METROPOLITAN GOVERNMENT OF NASHVILLE AND DAVIDSON COUNTY

STAFF RECOMMENDATION
1707 Holly Street
November 15, 2017

Application: New construction—outbuilding/detached accessory dwelling unit (DADU)
District: Lockeland Springs-East End Neighborhood Conservation Zoning Overlay
Council District: 06
Map and Parcel Number: 08314000400
Applicant: Van Pond Architect, PLLC
Project Lead: paul.hoffman@nashville.gov

<p>Description of Project: Application is to construct a detached accessory dwelling unit (DADU) at the rear of the lot. The proposed ridge height of the outbuilding exceeds that of the house.</p> <p>Recommendation Summary: Staff recommends approval of the detached accessory dwelling unit with the following conditions:</p> <ol style="list-style-type: none"> 1. The ridge height is reduced to eighteen feet (18') while maintaining the proposed roof pitch; 2. Staff approve windows, doors, shingle material, and roofing color prior to purchase and installation; 3. The balcony be reduced in size to thirty square feet (30 sq. ft.) or less and moved to the front or rear façade; 4. New drawings are submitted reflecting the conditions, prior to issuance of a permit; and, 5. Staff receive a

Figure 1. 1707 Holly Street

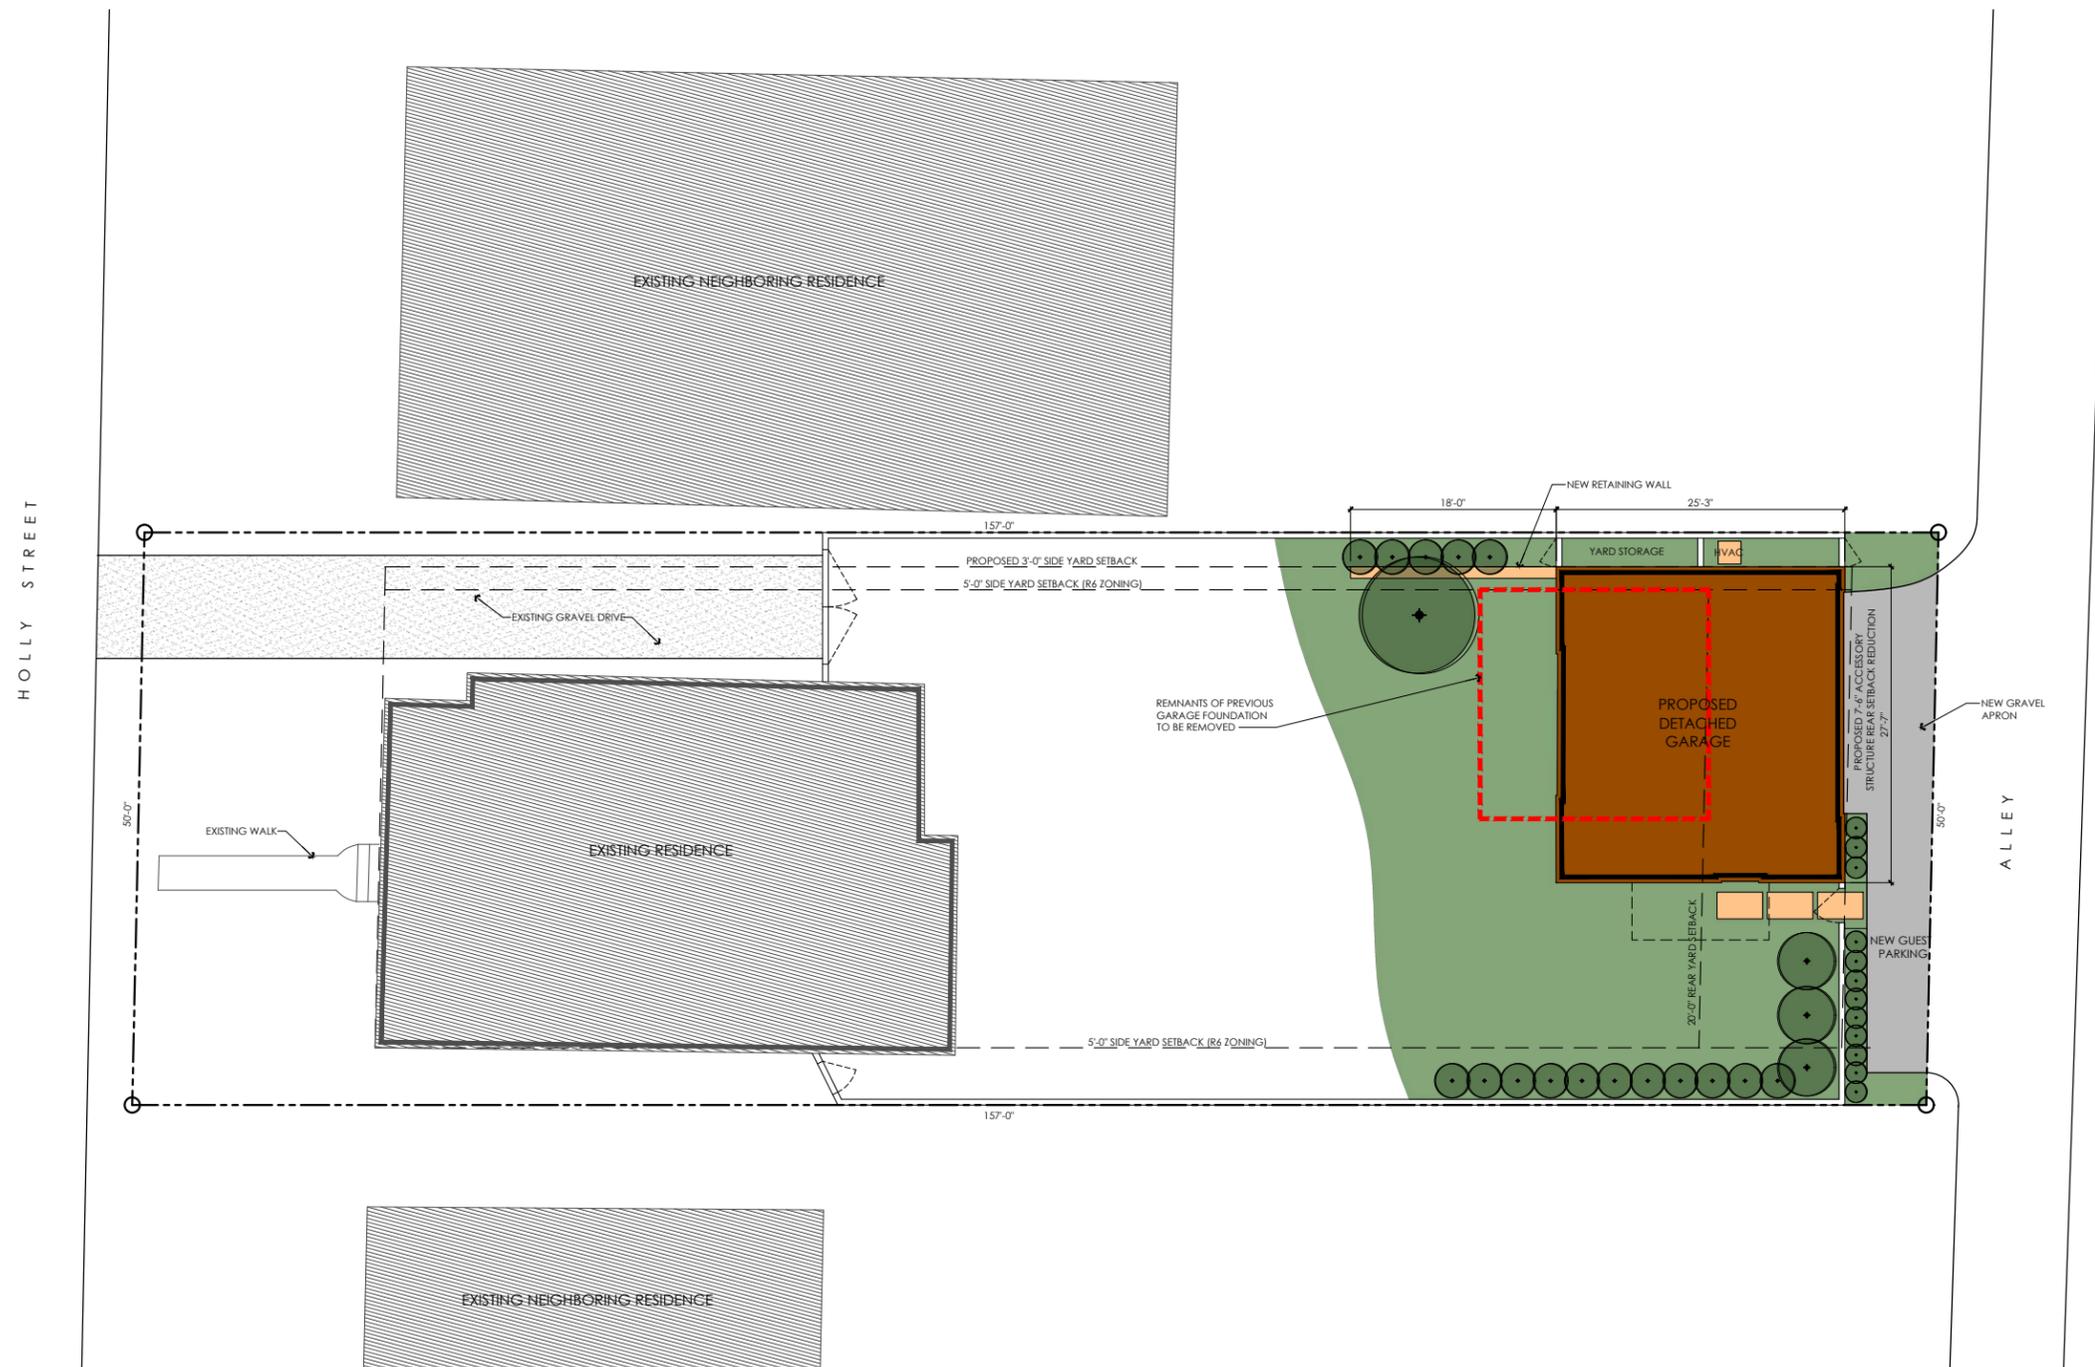
*The proposed ridge height is twenty-one feet (21') from grade, which is greater than the height of the historic home which is approximately eighteen feet (18') from finished floor to ridge. The design guidelines require that outbuildings be subordinate to principal dwellings. The proposed average eave height of twelve and one-half inches (12' ½") from finished for the outbuilding is similar to the average eave height of the principal dwelling which is approximately thirteen feet (13'). In

order to meet the design guidelines, the building’s overall height should not exceed eighteen feet (18’). Staff recommends approval with the condition that the ridge height be lowered to eight feet (8’), while maintaining the proposed roof slope since it matches the slope of the historic home. With this condition the project will meet Section II.B.8 of the design guidelines and Section 17.16.030.G.7 of Code.

1. The ridge height is reduced to eighteen feet (18') while maintaining the proposed roof pitch;

2 Upper Floor Plan
 SCALE 1/4" = 1'-0"

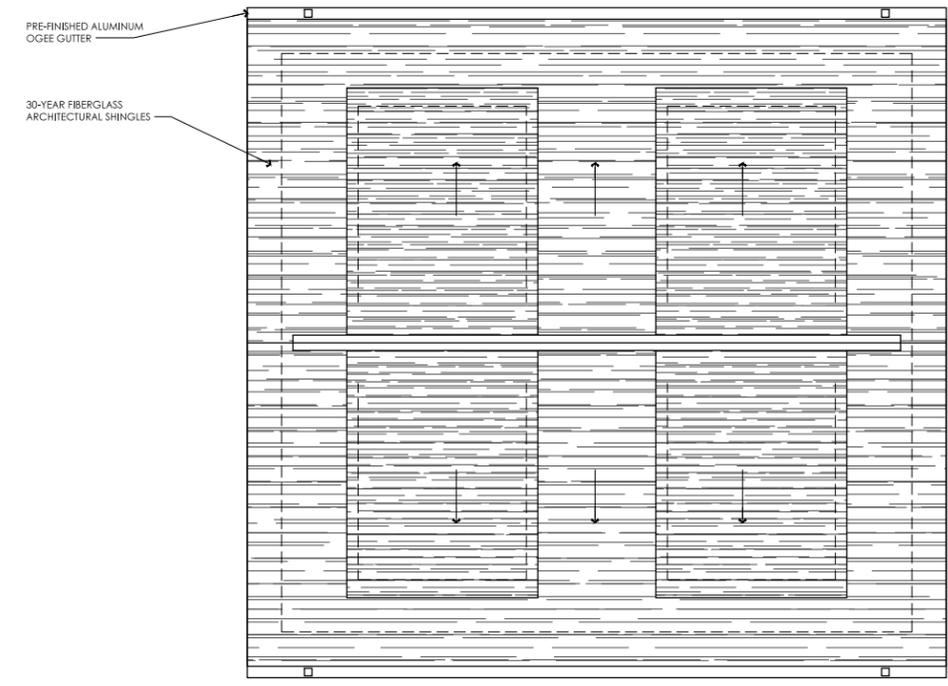
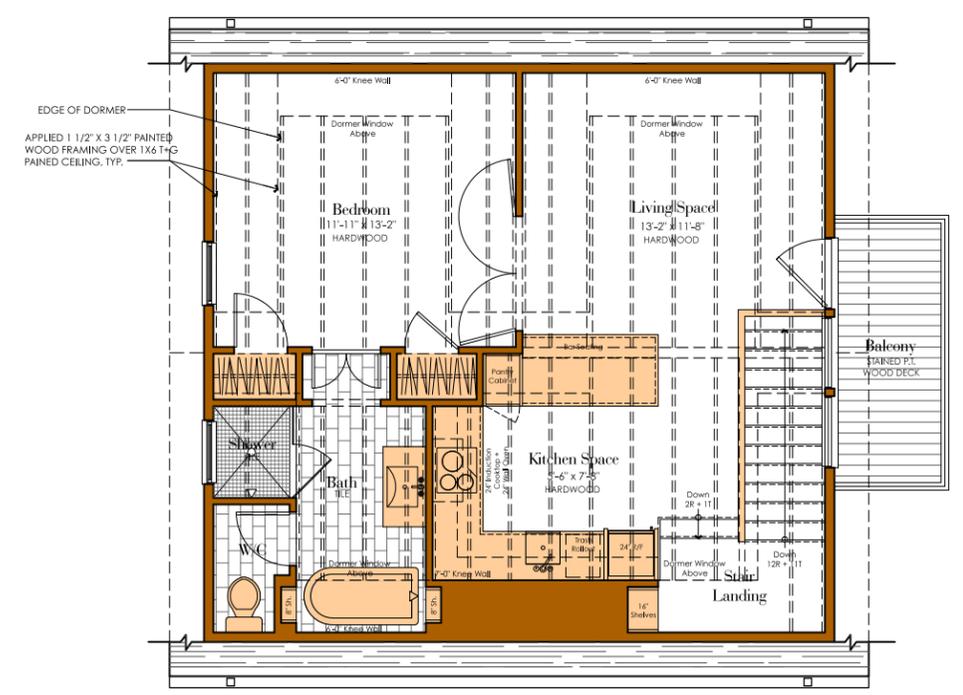
The applicant is proposing an uncovered balcony that is eleven feet (11’) wide and five feet (5’) deep, for fifty-five square feet (55 sq. ft.). If this balcony is included in the calculation of the footprint, the DADU’s footprint would be seven hundred and forty-four square feet (744 sq. ft.). In June, Staff recommended that the Commission consider creating a policy regarding balconies on outbuildings and DADUs. Staff recommends that upper level balconies on outbuildings and DADUs be permitted and not be included in either the footprint square footage allotment or the dwelling unit square footage allotment if they meet the following criteria:

The current proposal does not meet the policy in terms of square footage or location. Staff recommends approval with the condition that the balcony not exceed thirty square feet (30 sq. ft.) or less and that it is moved to a front or rear façade.

2. Staff approve windows, doors, shingle material, and roofing color prior to purchase and installation;
3. The balcony be reduced in size to thirty square feet (30 sq. ft.) or less and moved to the front or rear façade;
4. New drawings are submitted reflecting the conditions, prior to issuance of a permit; and,
5. Staff receive a copy of the filed restrictive covenant for the detached accessory dwelling unit prior to issuance of a permit.
